**DEMANDE DU TRANSPORTEUR RELATIVE À LA CONSTRUCTION D'UNE LIGNE
DE 735 KV ENTRE LES POSTES MICOUA ET DU SAGUENAY
(THE "MICOUA-SAGUENAY LINE")**

FILE R-4052-2018

**NALCOR ENERGY MARKETING CORPORATION
("NEMC")**

**PRESENTED TO THE
RÉGIE DE L'ÉNERGIE DU QUÉBEC
("RÉGIE")**

Figure 3

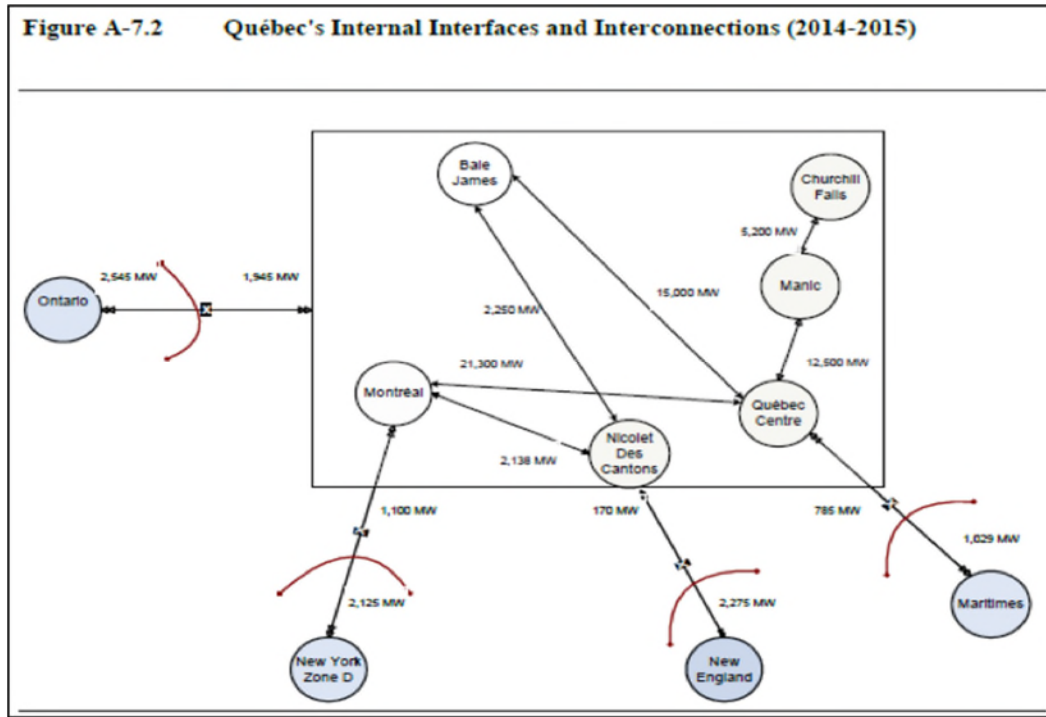
35. As shown above, the transfer capacity for the Churchill Falls-Manic corridor has remained constant at 5,200 MW, but the Manic-Québec corridor has varied significantly from a low of 11,750 MW in 2008 to a high of 13,200 MW for the

2018-2019 winter peak in the 2014 review. In the 2017 review, the Manic-Québec corridor transfer capacity was revised down to 12,500 MW for 2017-2018 through 2021-2022. These variations in transfer capacity will be discussed later.

Figure 5

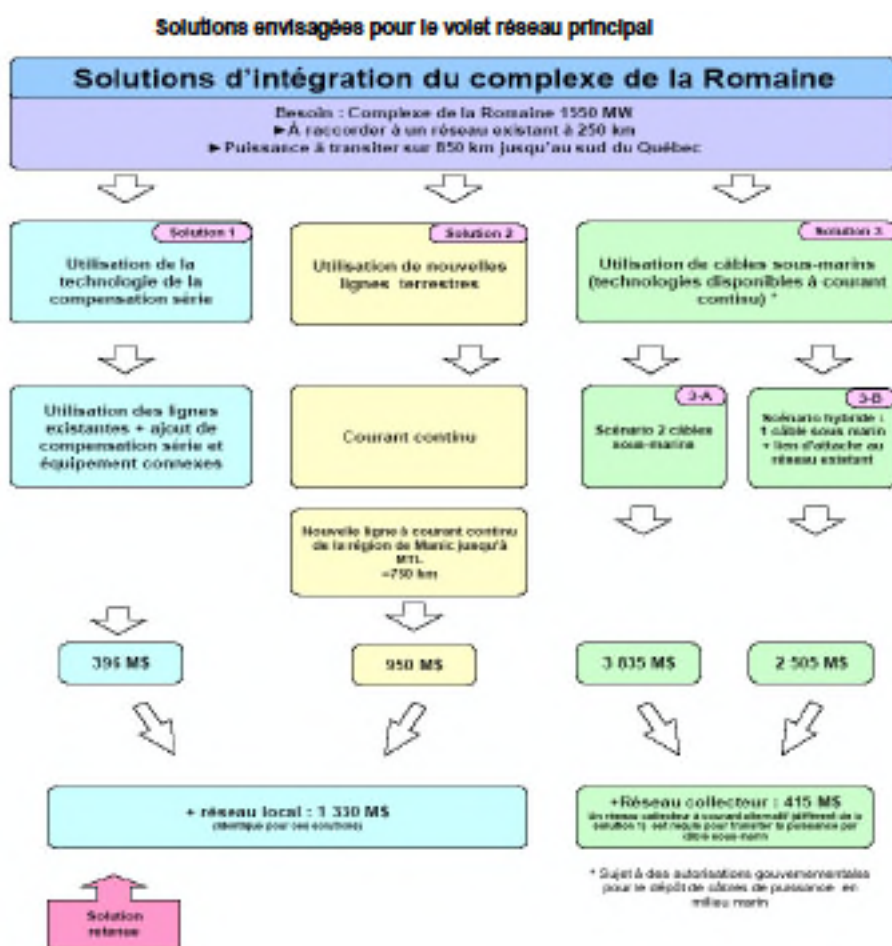
62. As one can notice, solution 3 was too expensive to be considered as a realistic alternative. Solution 1 (series compensation) and 2 (above ground transmission line) are similar in nature to solution 3 (series compensation) and solution 1 (above ground transmission line) in the current Micoua-Saguenay file.

Figure 1 – Projets identifiés pour l'amélioration de la sécurité du réseau face au verglas

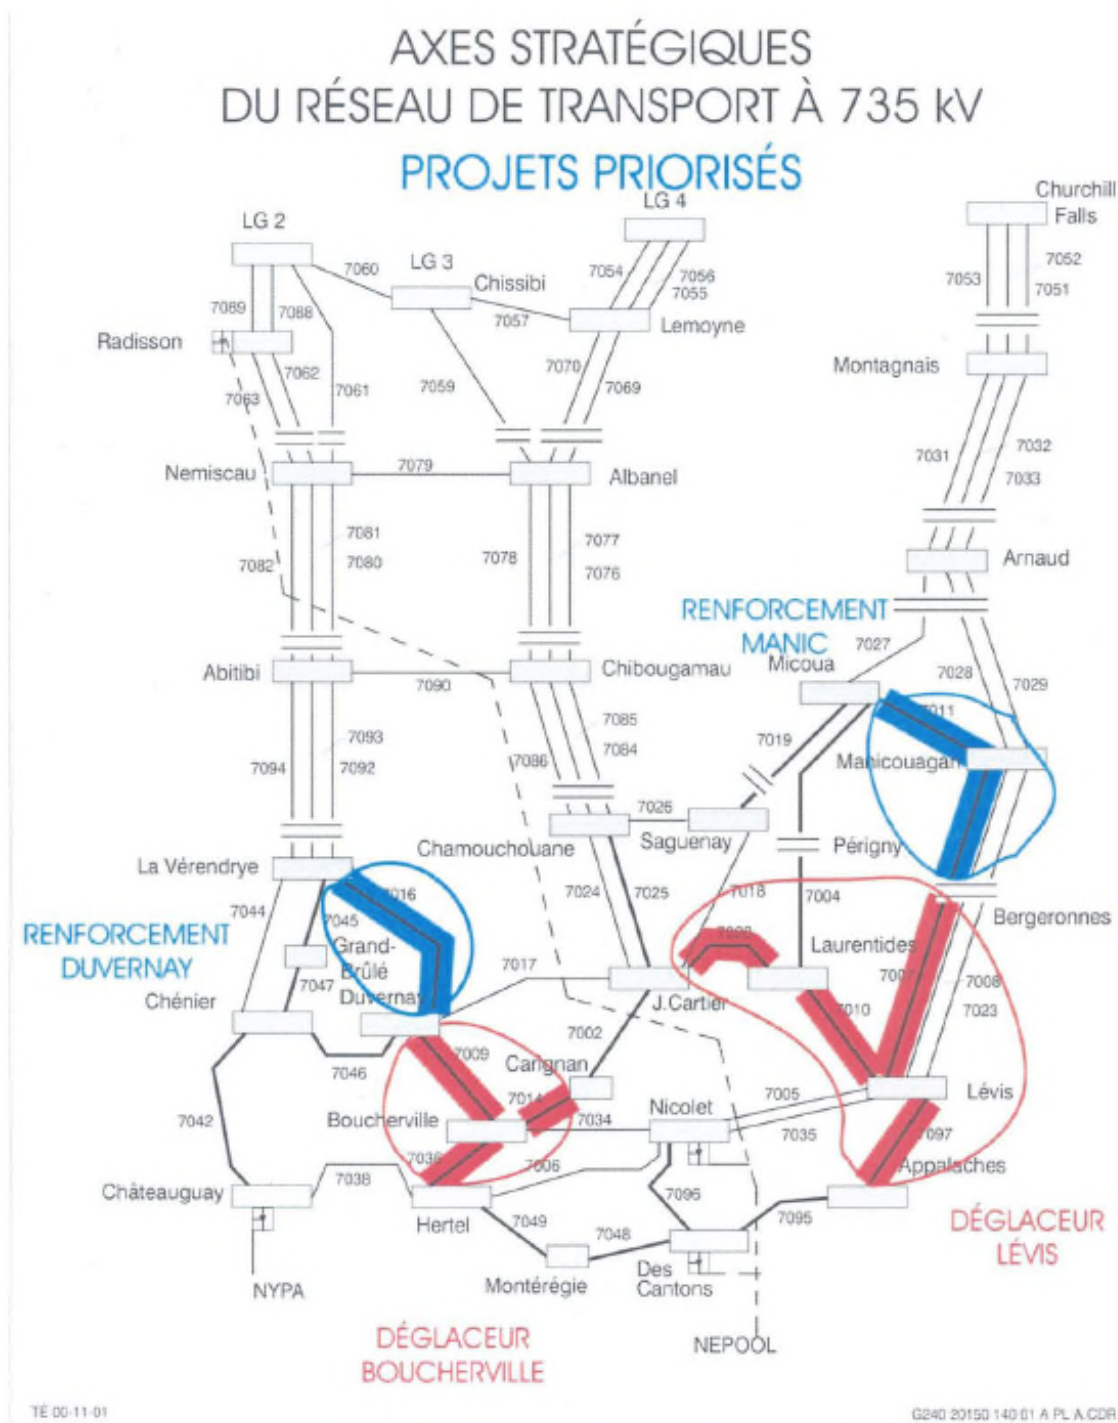
105. It is important to note that HQT did not include ice storm protection in its original evidence. It has only been included after the Régie requested that the economic
